VIRGINIA ELECTRIC AND POWER COMPANY
RICHMOND, VIRGINIA 23261

November 7, 2022

VIRGINIA ELECTRIC AND POWER COMPANY (DOMINION ENERGY VIRGINIA)
NORTH ANNA POWER STATION UNITS 1 AND 2
SURRY POWER STATION UNITS 1 AND 2
PROPOSED LICENSE AMENDMENT REQUEST TO
REVISE EMERGENCY PLAN STAFF AUGMENTATION TIMES

FIGURE 5.5-d

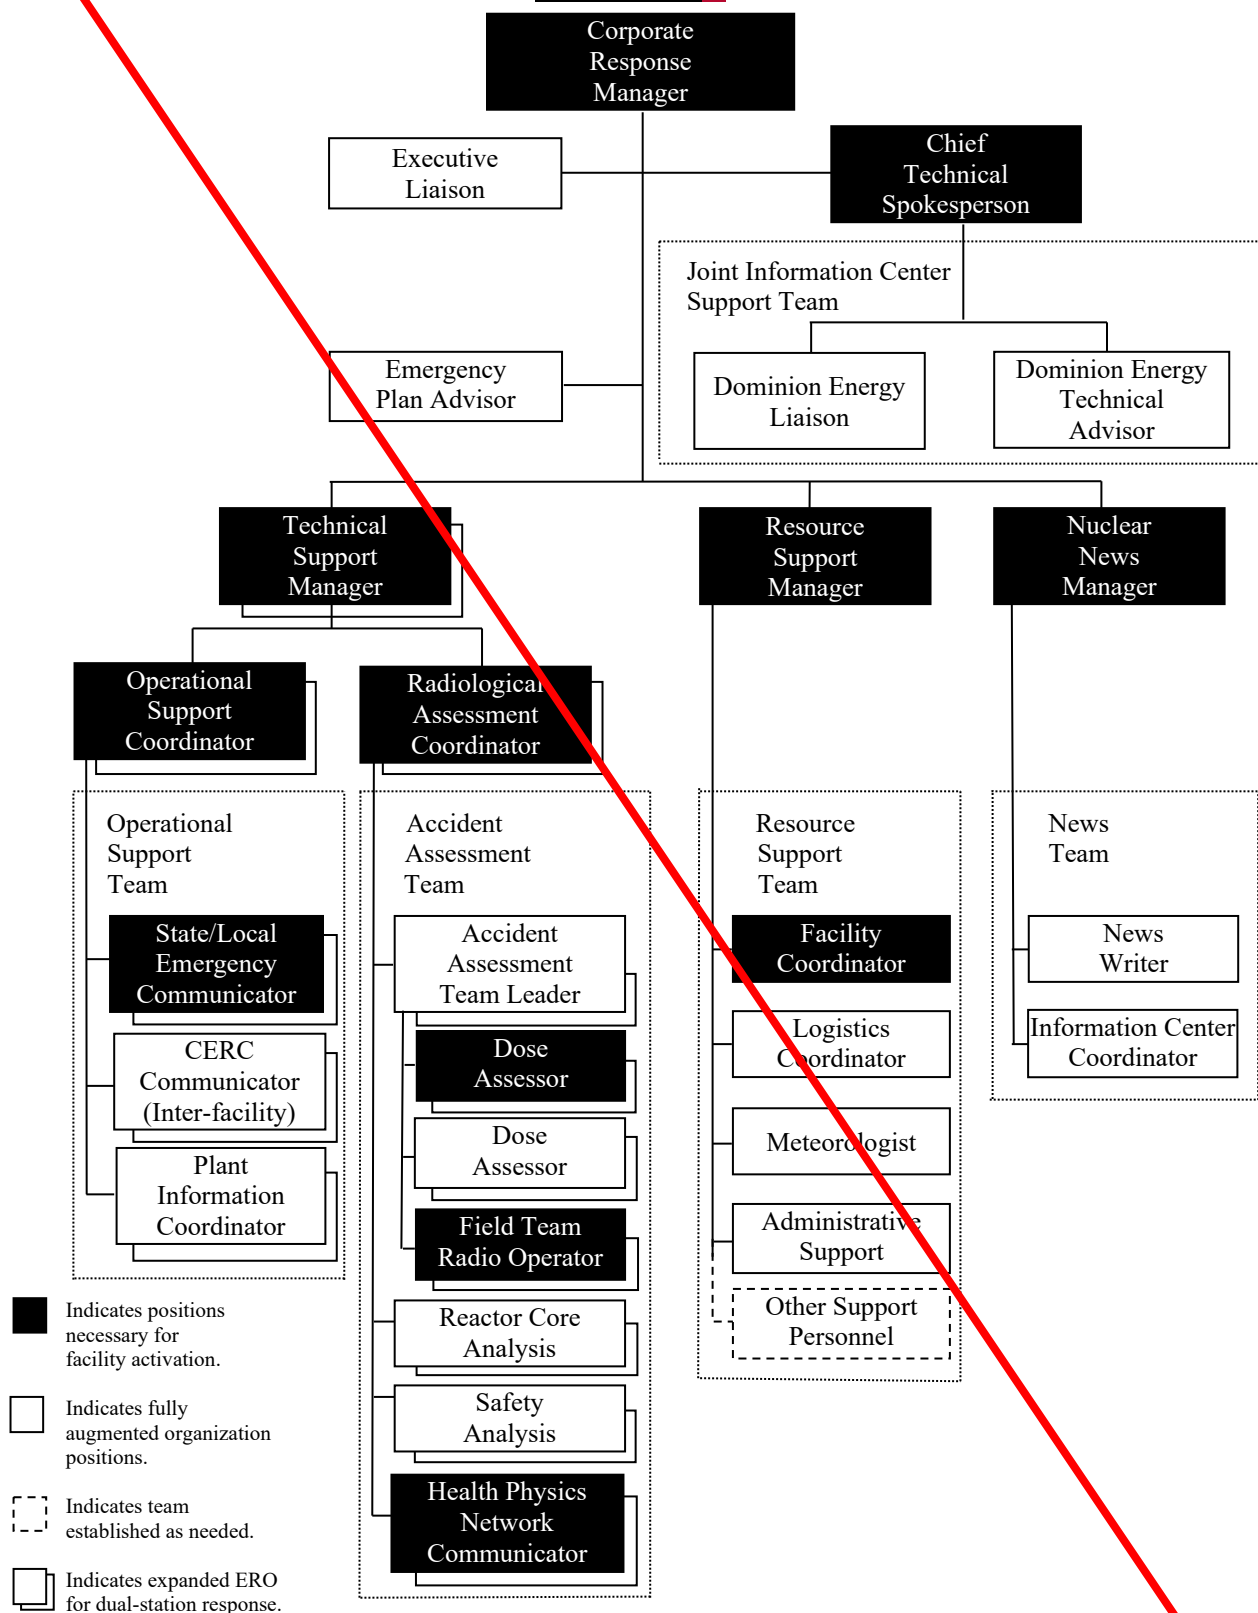
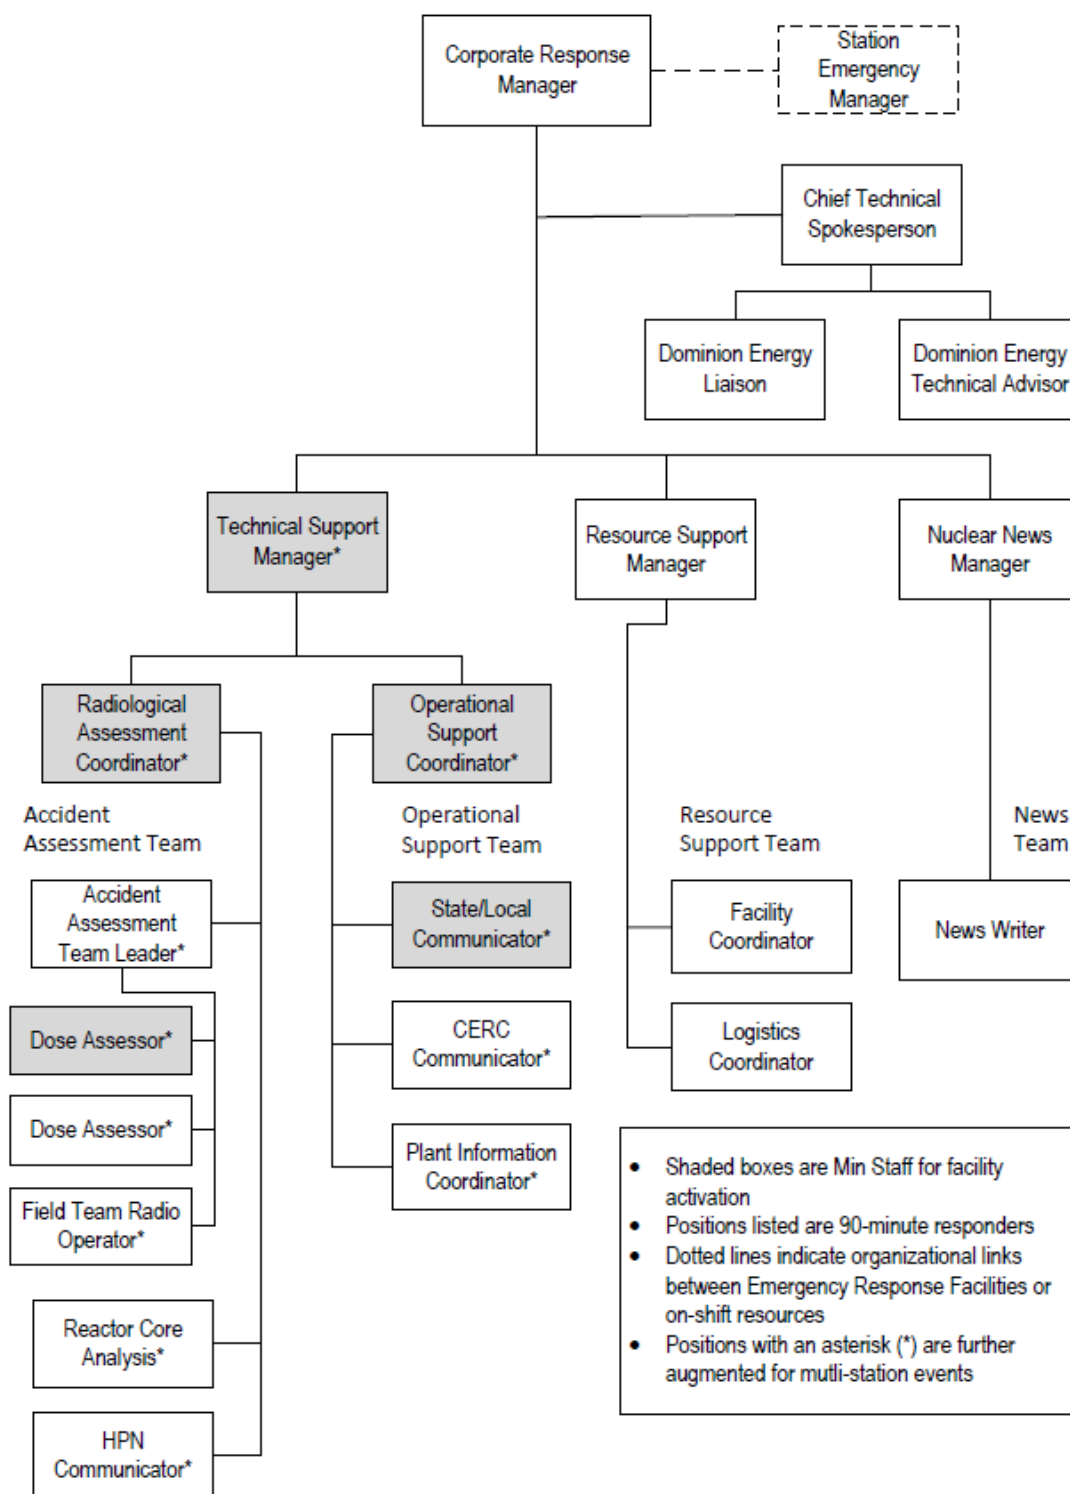
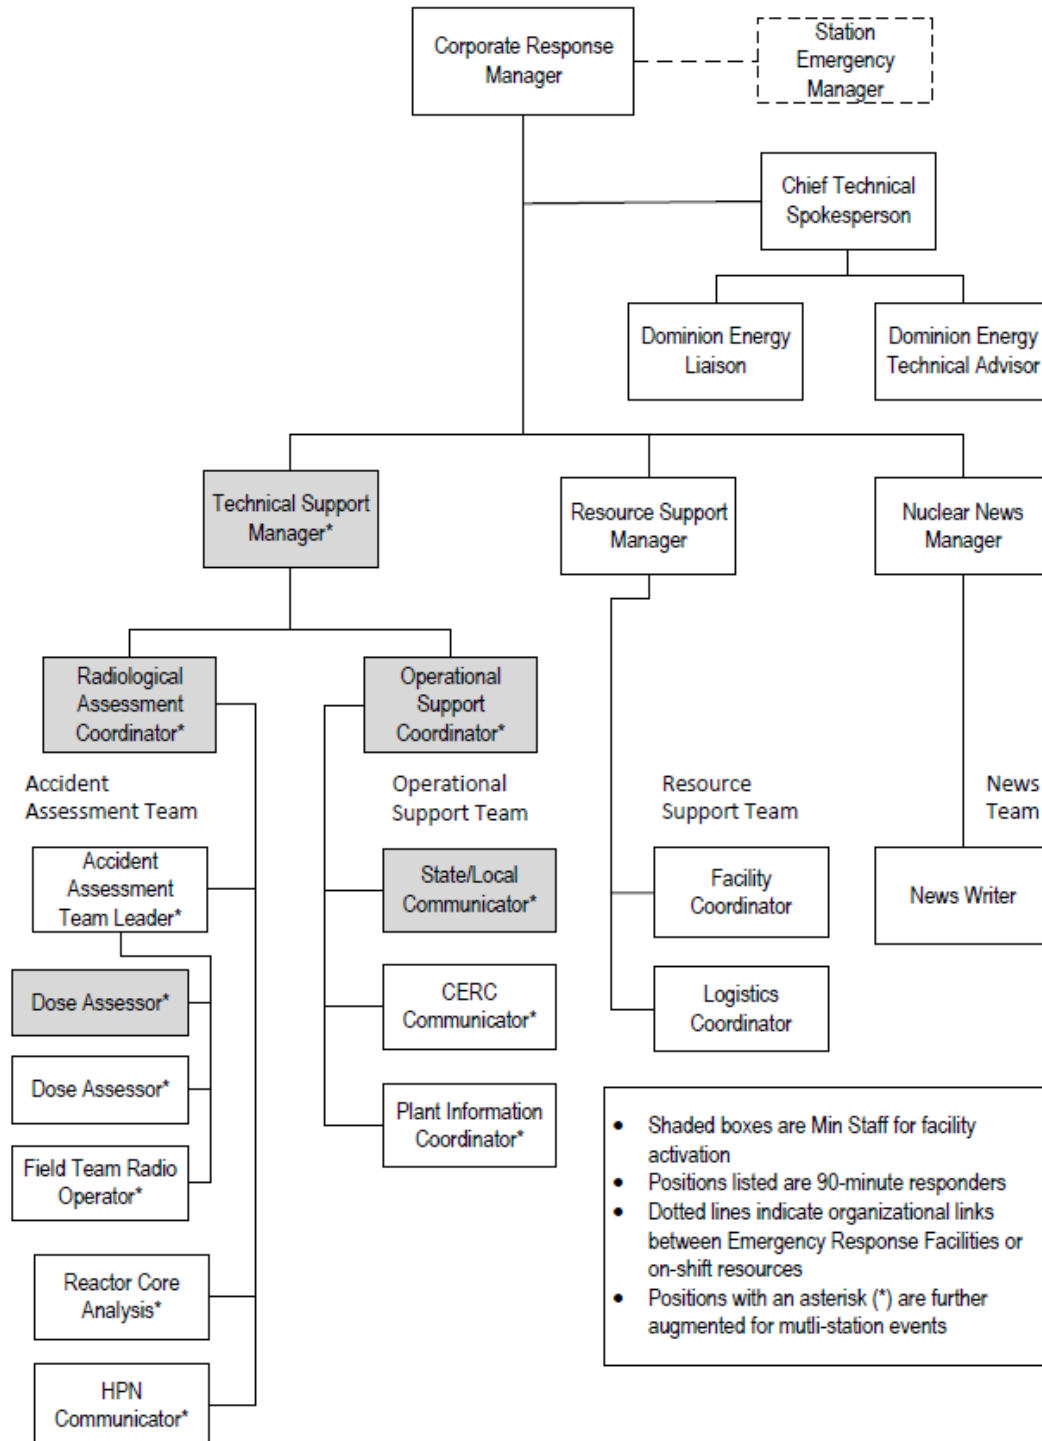
- ww. Figure 5.5.d, "Corporate Emergency Response Center Organization," renumbered section and revised to reflect proposed staffing and positions required for facility activation.

FIGURE 5.1

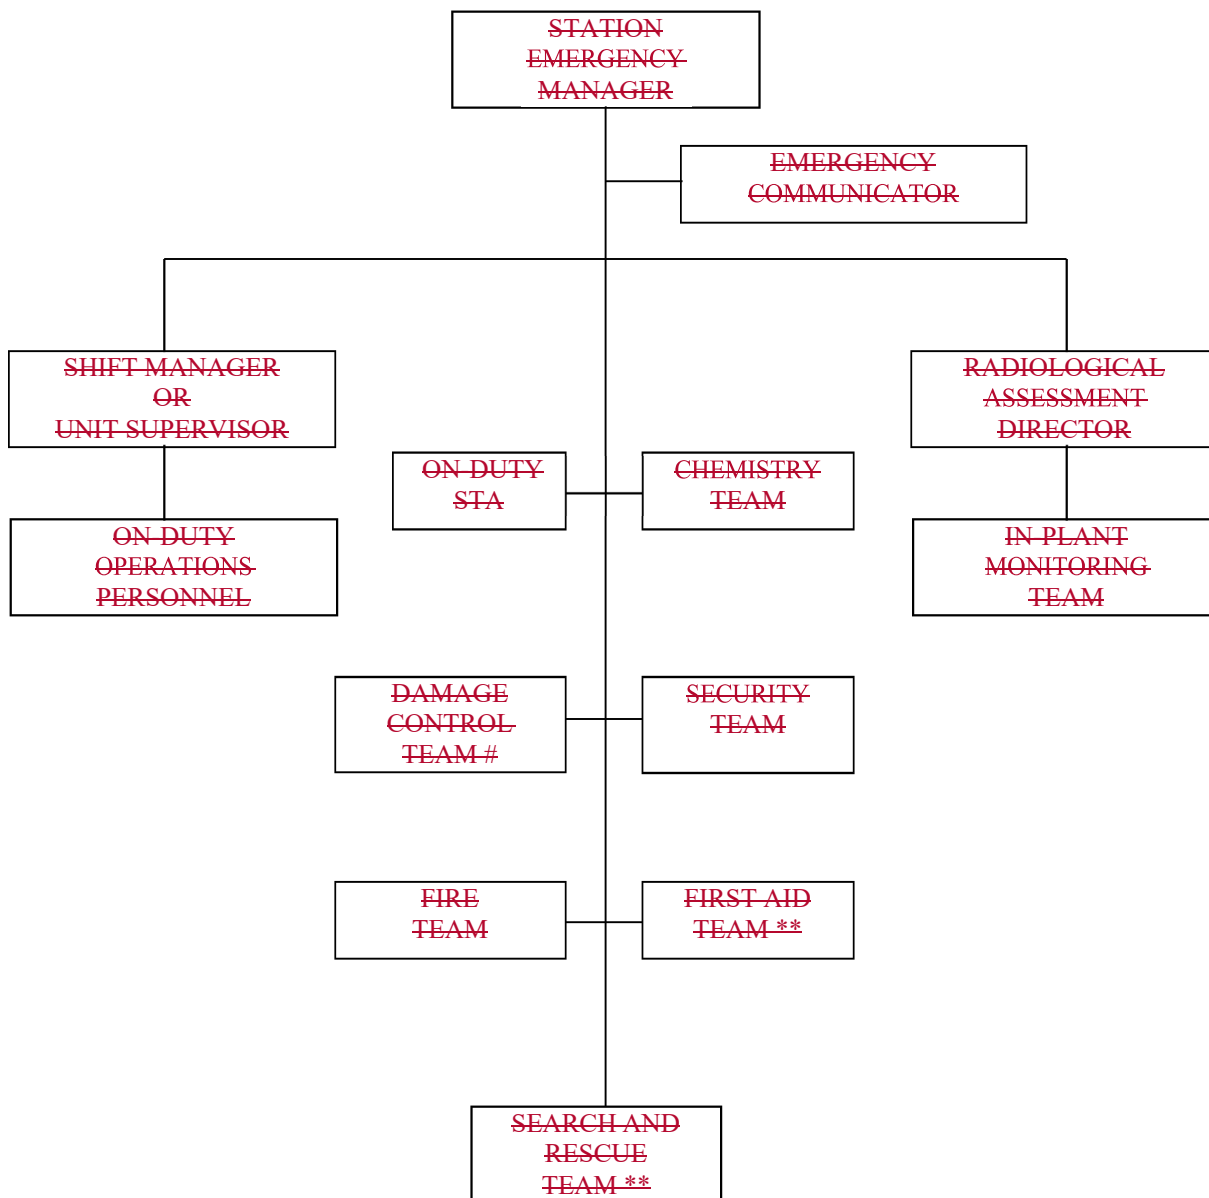
- pp. Figure 5.1, "Station Emergency Organization Prior to Augmentation," deleted figure. This figure duplicated information included in the revised Table 5.1, as well as revised Figures 5.3, 5.4, and 5.5.

FIGURE 5.2

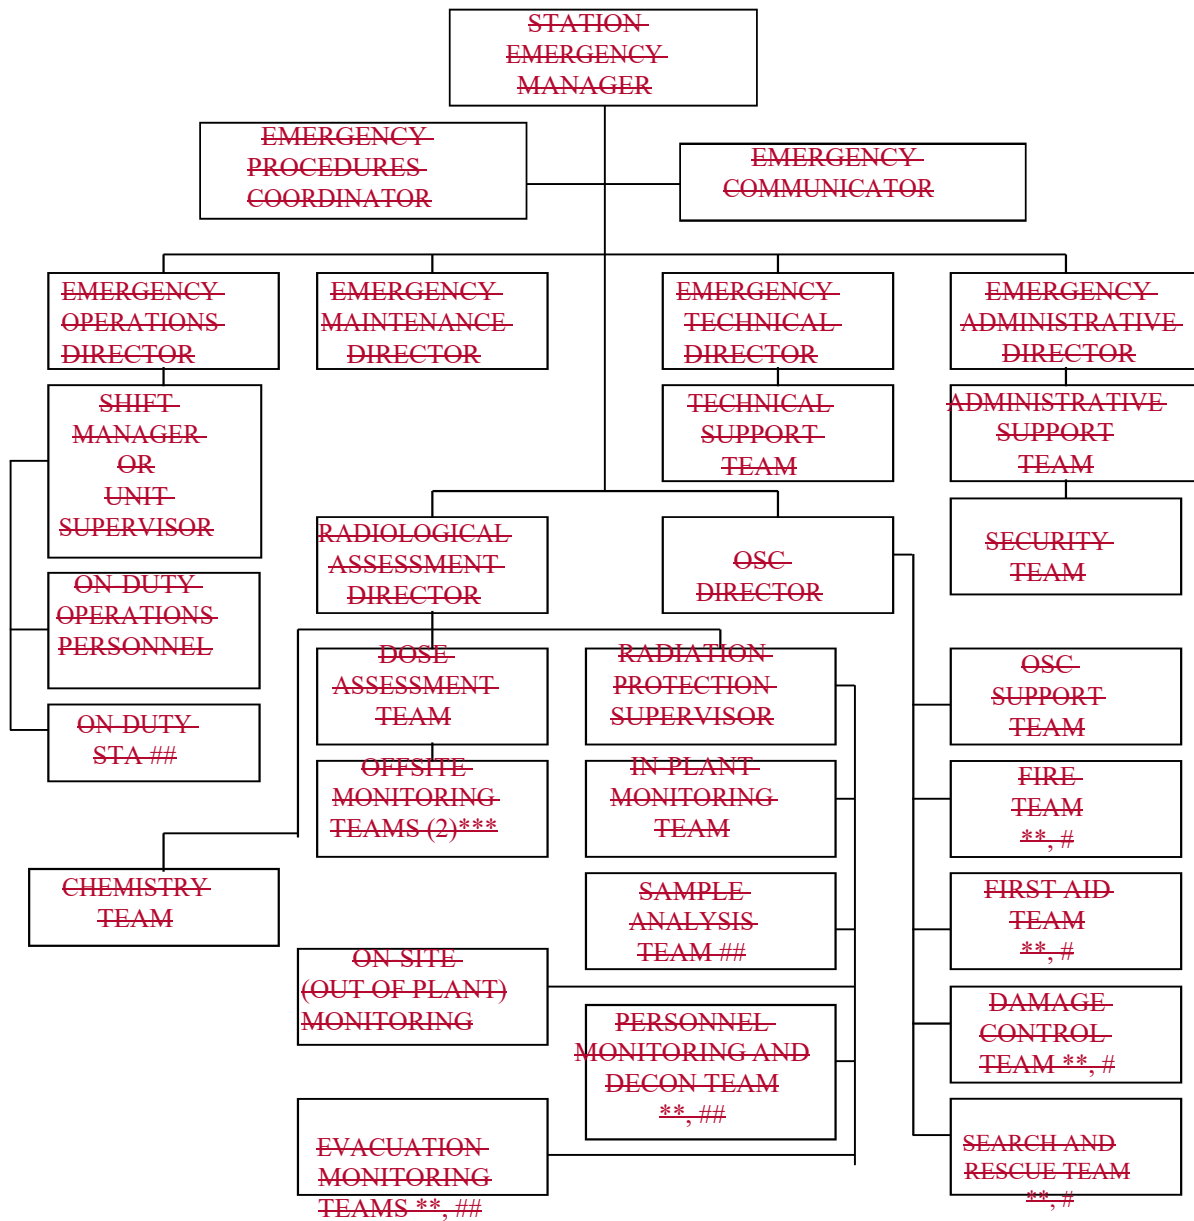
- qq. Figure 5.2, "Station Emergency Organization Following Augmentation," deleted. This figure duplicated information included in the revised Table 5.1, as well as revised Figures 5.3, 5.4, and 5.5.

STATION TO SUPPORT GROUP INTERFACE
PRIOR TO AUGMENTATION OF THE ONSITE EMERGENCY ORGANIZATION
FIGURE 5.13

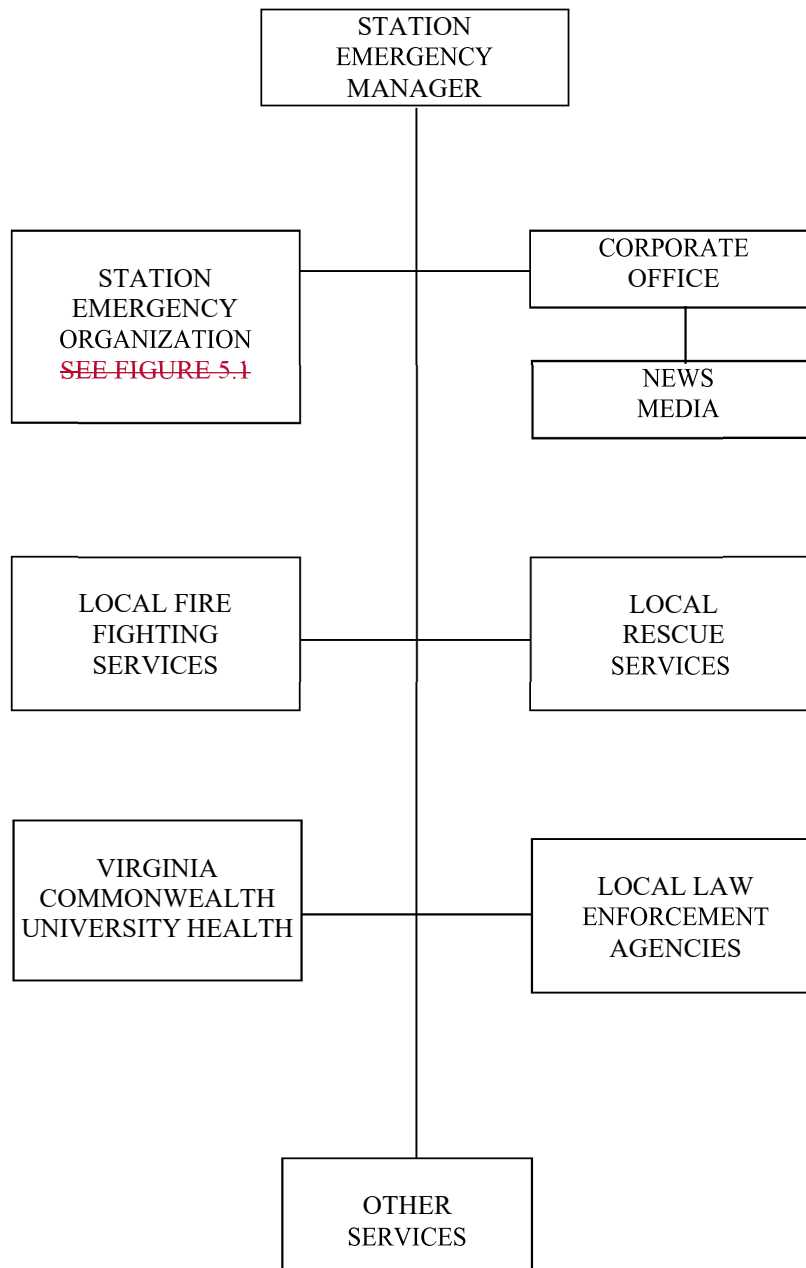
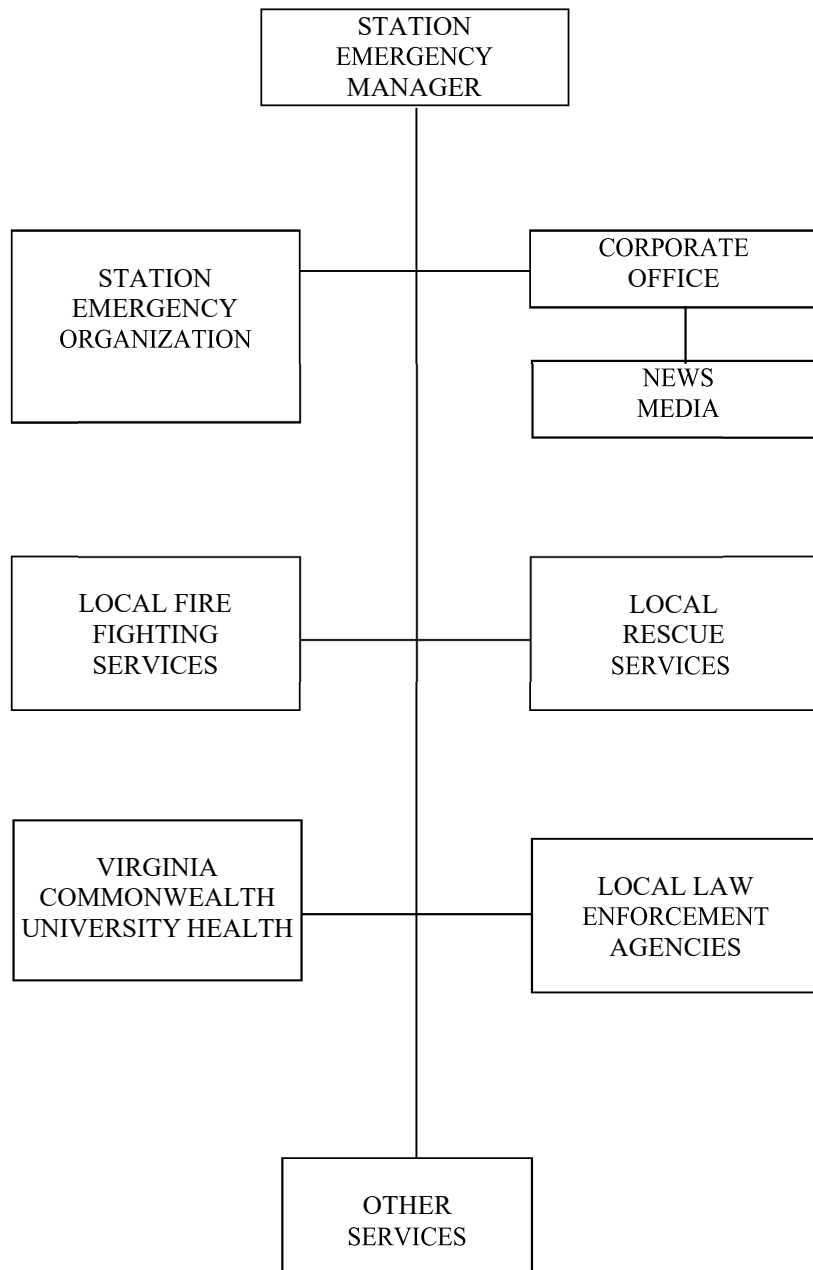
- rr. Figure 5.3, "Station to Support Group Interface Prior to Augmentation of the Emergency Organization," renumbered section and revised to reflect changes in associated figures.
